Davis-Besse Nuclear Power Station  
5501 North State Route 2  
Oak Harbor, Ohio 43449-9760

Subject: License Amendment Application to Increase Spent Fuel Storage Capability  
(License Amendment Request No. 98-0013)

APPLICATION FOR AMENDMENT  
TO  
FACILITY OPERATING LICENSE NUMBER NPF-3  
DAVIS-BESSE NUCLEAR POWER STATION  
UNIT NUMBER 1

**SAFETY ASSESSMENT AND SIGNIFICANT HAZARDS CONSIDERATION  
FOR  
LICENSE AMENDMENT REQUEST NUMBER 98-0013**

Figure 3.9-1  
Burnup vs. Enrichment Curves  
For the Davis-Besse Low Density  
Spent Fuel Pool Storage Racks

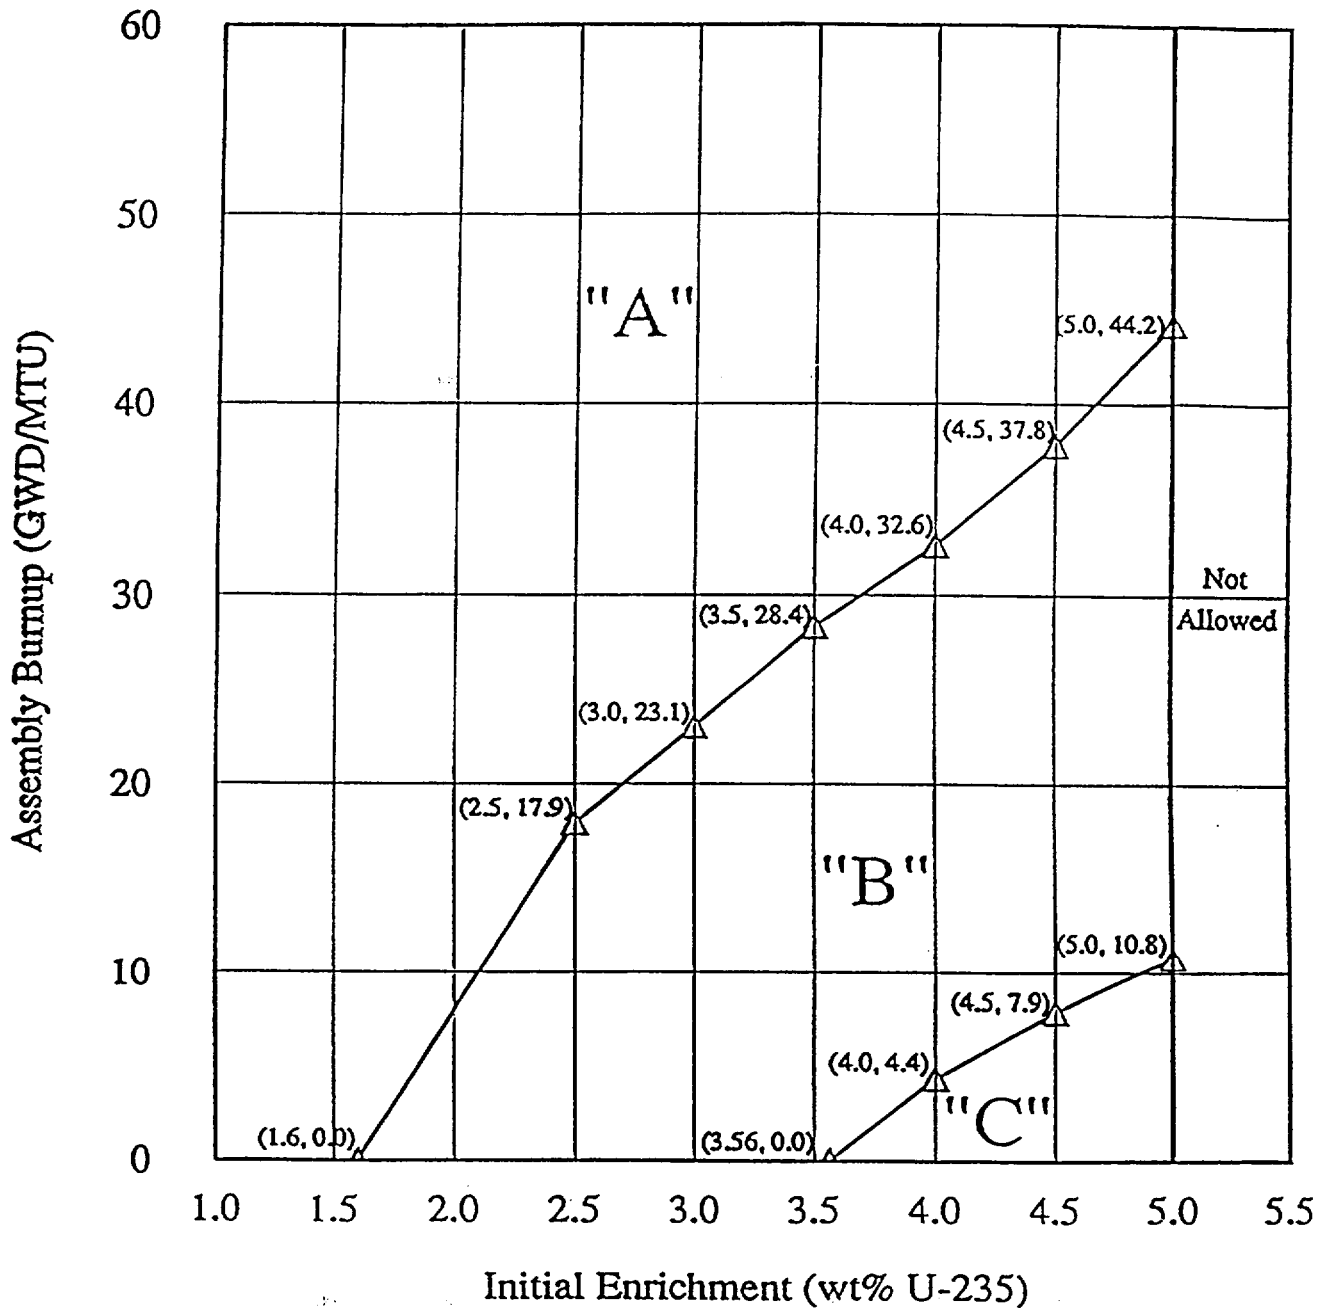
It is proposed to revise LCO 3.9.13 and SR 4.9.13.1 to include provisions regarding storage of fuel assemblies in high density racks in the SFP and the transfer pit. In addition, the title of Figure 3.9-1 is proposed to be revised to clarify that it applies to the low density racks in

Bases changes are proposed that relate to the proposed changes to the associated LCO. An additional Bases change is proposed that clarifies that the term “directly adjacent” as used in Figure 3.9-1 refers to fuel assemblies stored face-to-face. These Bases changes are administrative changes that will have no adverse effect on nuclear safety.

The restrictions on the placement of fuel assemblies within the spent fuel pool, and cask pit, and transfer pit, as dictated by Figure 3.9-1, and Figure 3.9-2, and Figure 3.9-3, ensure that the k-effective of the spent fuel pool, and cask pit, and transfer pit will always remain less than 0.95 assuming the spent fuel pool, and cask pit, and transfer pit to be flooded with non-borated water. The restrictions delineated in Figure 3.9-1, and Figure 3.9-2, and Figure 3.9-3, and the action statement, are consistent with the criticality safety analyses performed for the spent fuel pool, and cask pit, and transfer pit. The term "directly adjacent" as used in Figure 3.9-1 refers to fuel assemblies stored face-to-face.

Figure 3.9-2  
Burnup vs. Enrichment Curve  
For the Davis-Besse High Density  
Cask Pit Storage Racks

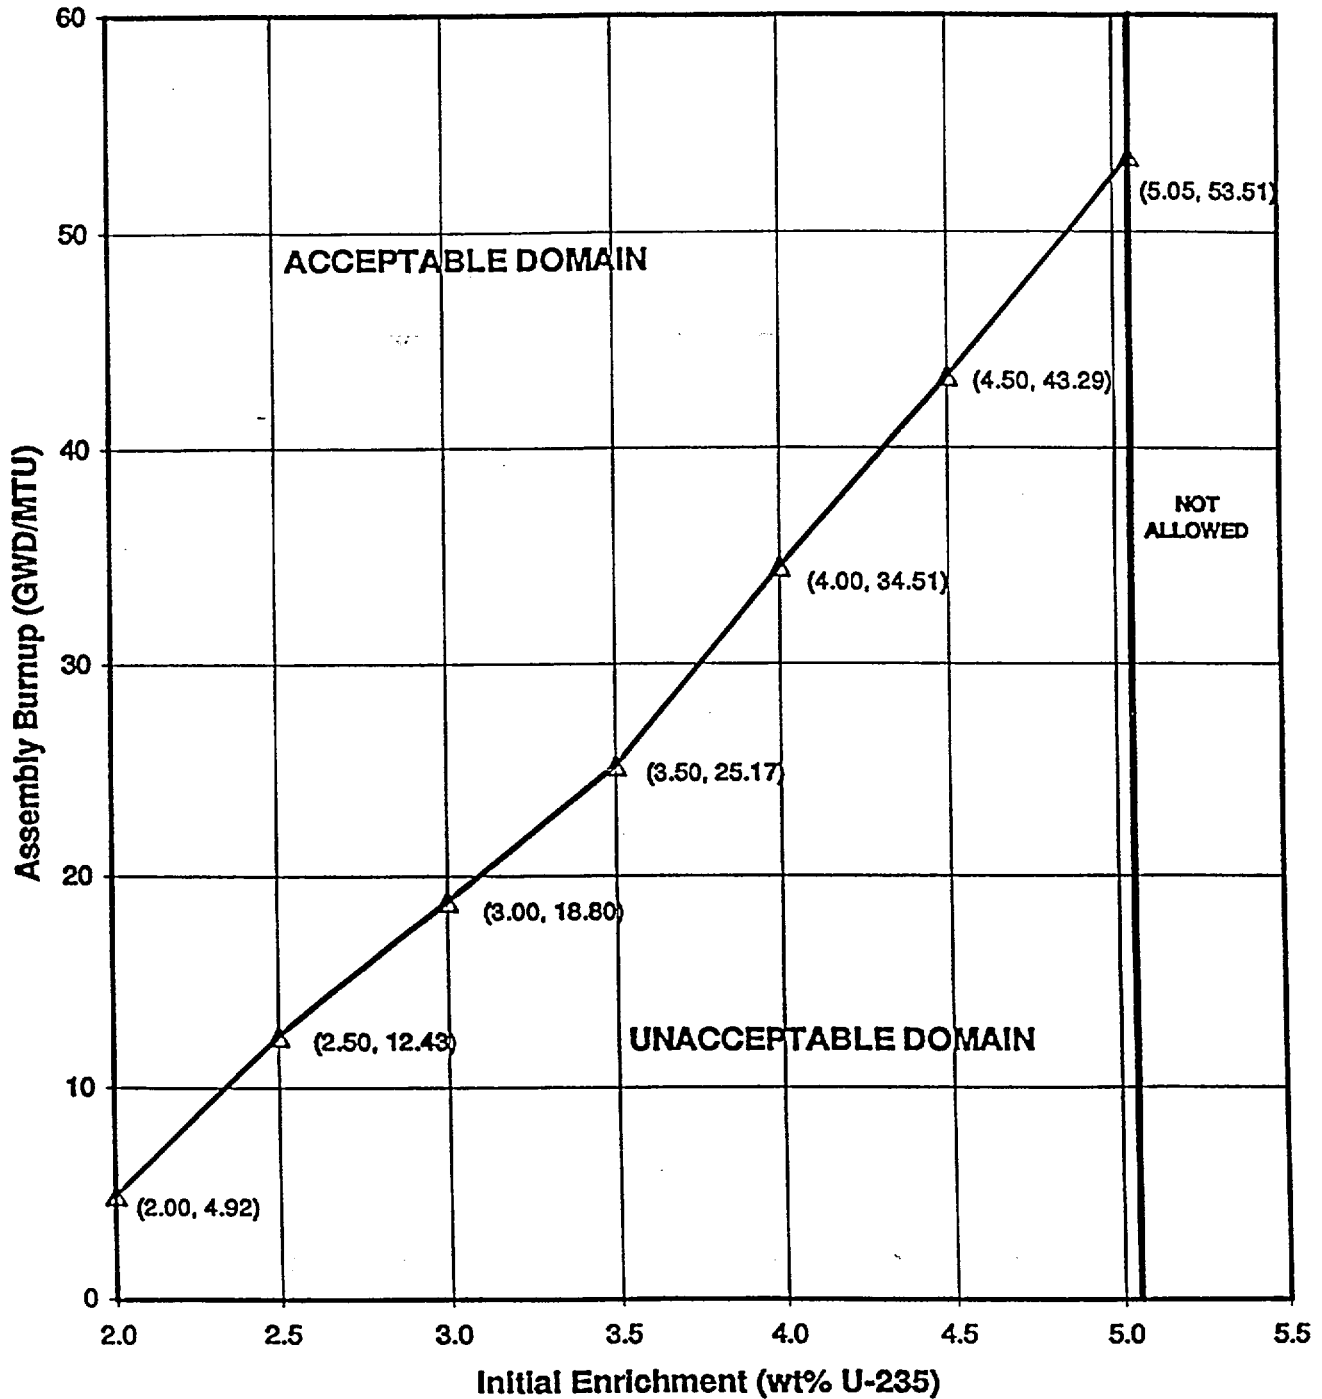
the SFP, and the title of Figure 3.9-2 is proposed to be revised to clarify that it applies to the high density racks in the cask pit. A new Figure 3.9-3 is proposed to be added that applies to the high density racks in the SFP and transfer pit. Related changes to Bases 3/4.9.13 are also proposed, including the addition of cross-references to Specifications 5.6.1.1 and 5.6.1.3 for a description of the design features of the low and high density spent fuel storage racks, respectively. In addition, a change to Bases 3/4.9.13 is proposed to clarify the term “directly adjacent” as used in Figure 3.9-1.

Figure 3.9-3  
Burnup vs. Enrichment Curves  
For the Davis-Besse High Density  
Spent Fuel Pool and Transfer Pit Storage Racks

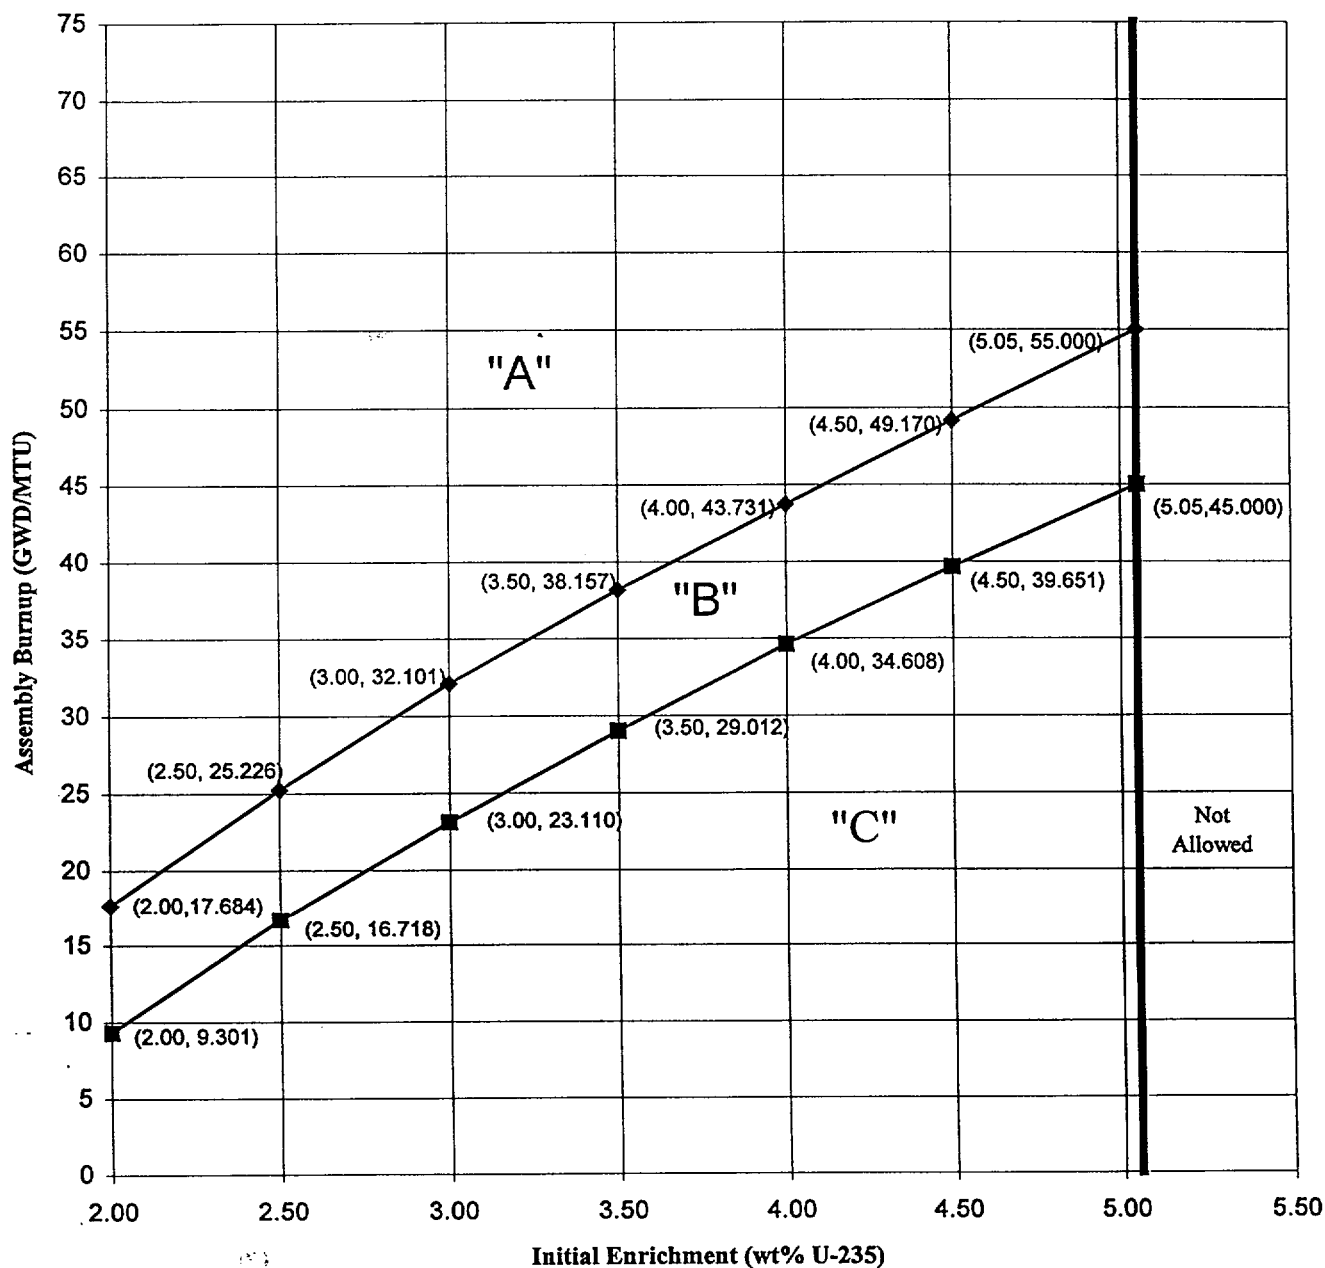
The proposed new Figure 3.9-3, "Burnup vs. Enrichment Curves For the Davis-Besse High Density Spent Fuel Pool and Transfer Pit Storage Racks," incorporates new requirements specific to the new spent fuel storage racks. The figure provides burnup/enrichment limitations appropriate for the spent fuel storage rack configurations, consistent with the criticality safety analyses performed. As such, this proposed change will have no adverse effect on nuclear safety.

- a. Fuel assemblies stored in the spent fuel pool shall ~~be placed in the spent fuel storage racks in accordance with~~ meet the criteria shown in Figure 3.9-1, when located in the low density spent fuel storage racks.
- b. Fuel assemblies stored in the cask pit shall ~~be placed in the spent fuel storage racks in accordance with~~ meet the criteria shown in Figure 3.9-2, when located in the high density spent fuel storage racks.
- c. Fuel assemblies stored in the spent fuel pool or transfer pit shall meet the criteria shown in Figure 3.9-3, when located in the high density spent fuel storage racks.
